Jefferson County School District Metolius Elementary School Upgrades

ADDENDUM NO. 01 June 01, 2023 - Revised June 30, 2023

CLARIFICATIONS: To the Construction Documents
PART 1: Revisions to the Project Manual
PART 2: Revisions to the Working Drawings
PART 3: Substitution Requests

1 MECHANICAL FLOOR PLAN - LEVEL 1 SECTOR B
M2.11 SCALE: 1/8" = 1'-0"

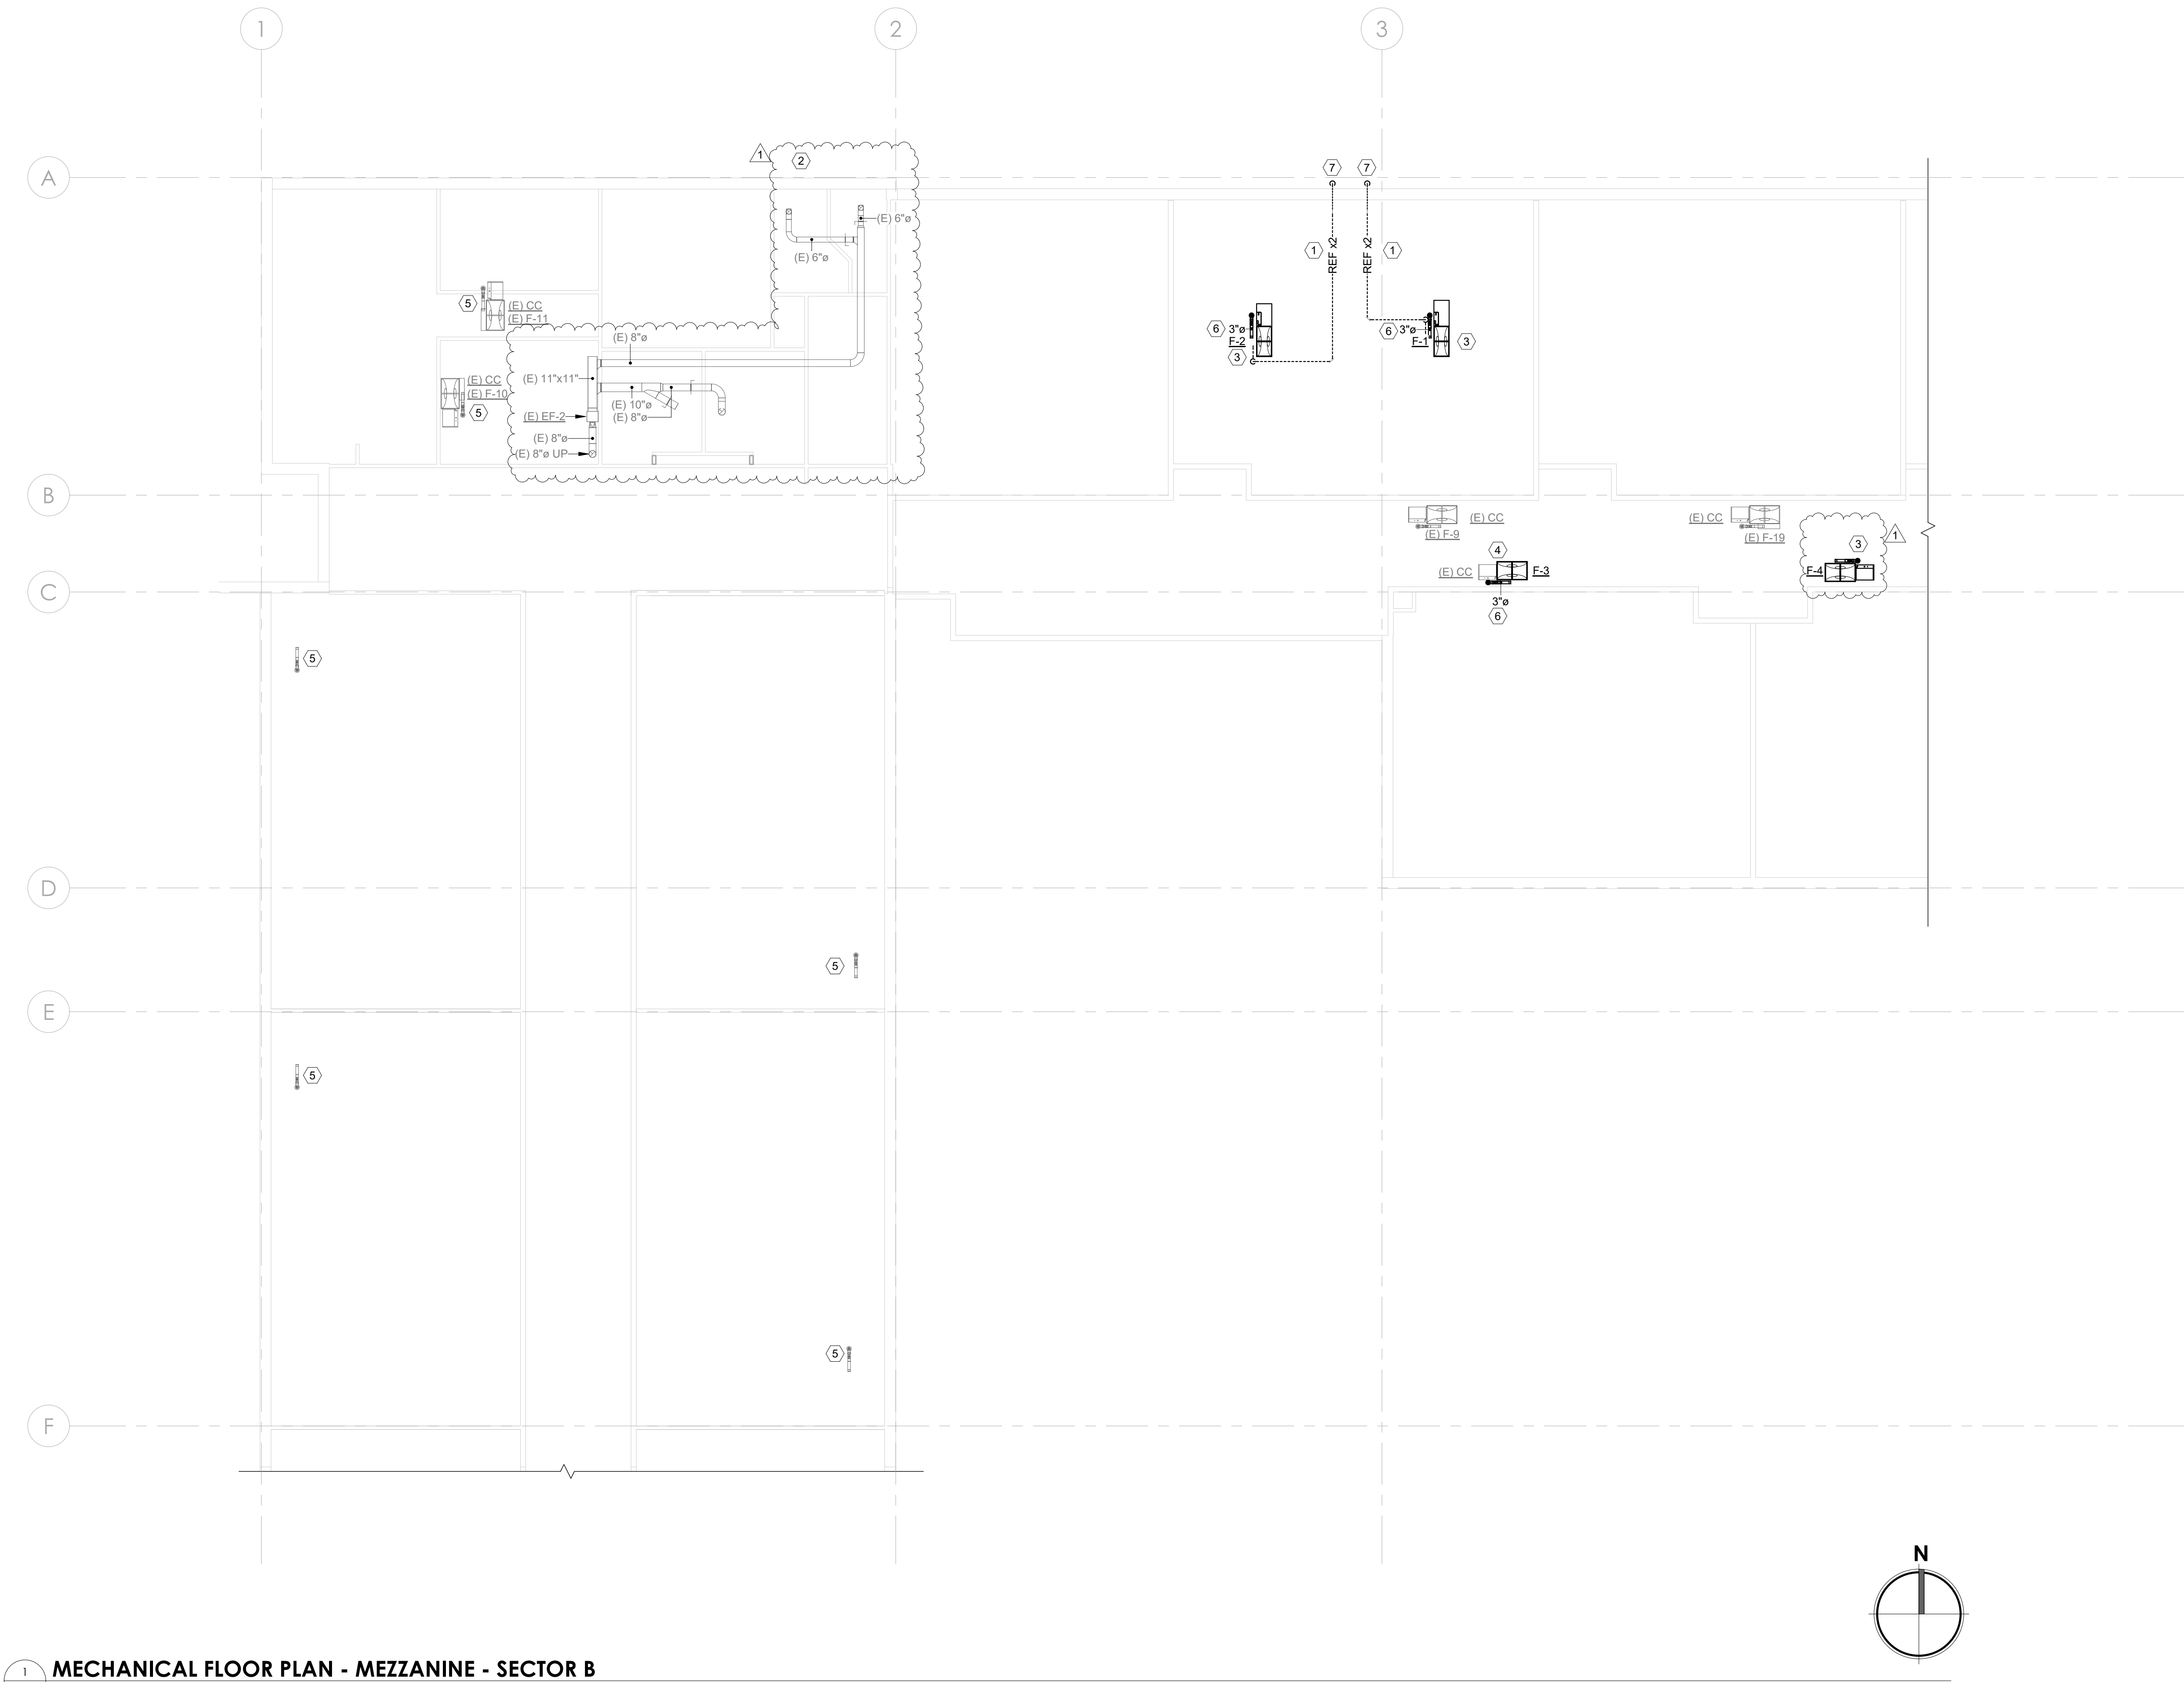
A) Detail 6 – Added product information for transition strip.
- 2.6 Modifications to Sheet M2.11 – Floor Plan – Level 1 – Sector B:
A) Added tags to ductwork

1 ELECTRICAL FLOOR PLAN - LEVEL 1 SECTOR B
E2.11 SCALE: 1/8" = 1'-0"

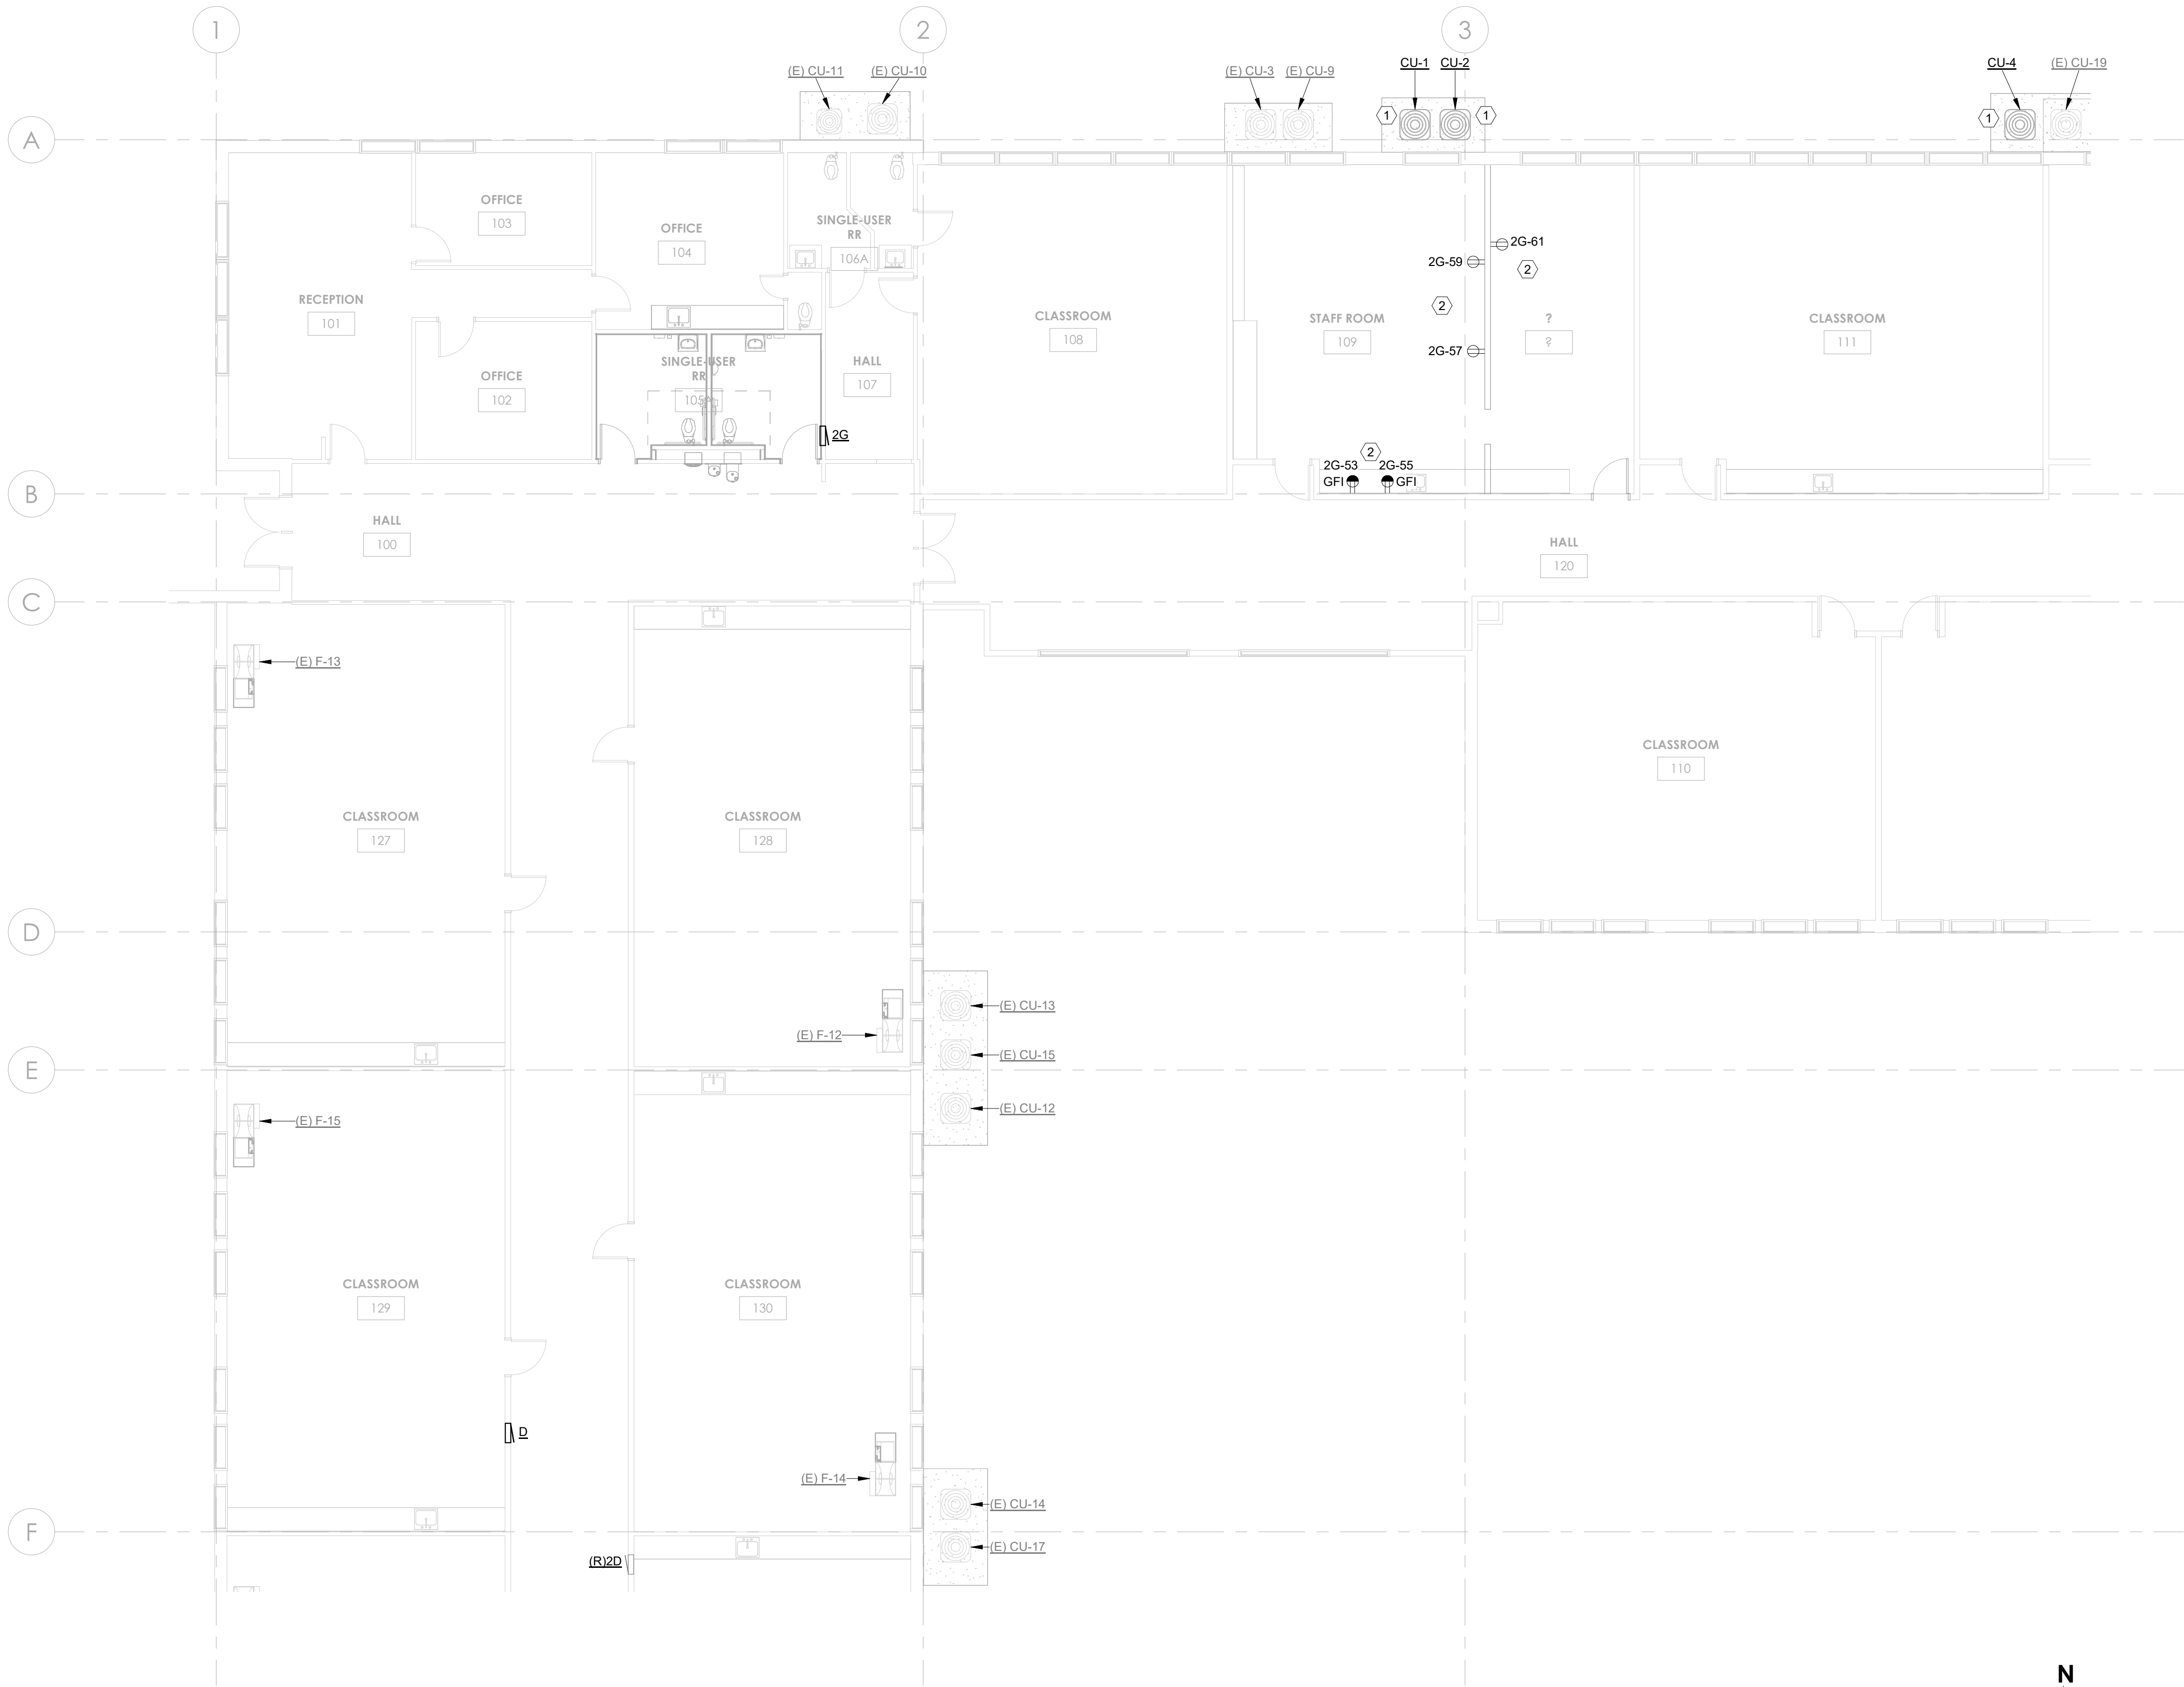
A) Speaker/strobes added to single-user restrooms 105A and room 135.
- 2.13 Modifications to Sheet E2.11 – Floor Plan – Level 1 – Sector B:
A) Key note 2 revised to more clearly refer to the receptacles in the staff room.
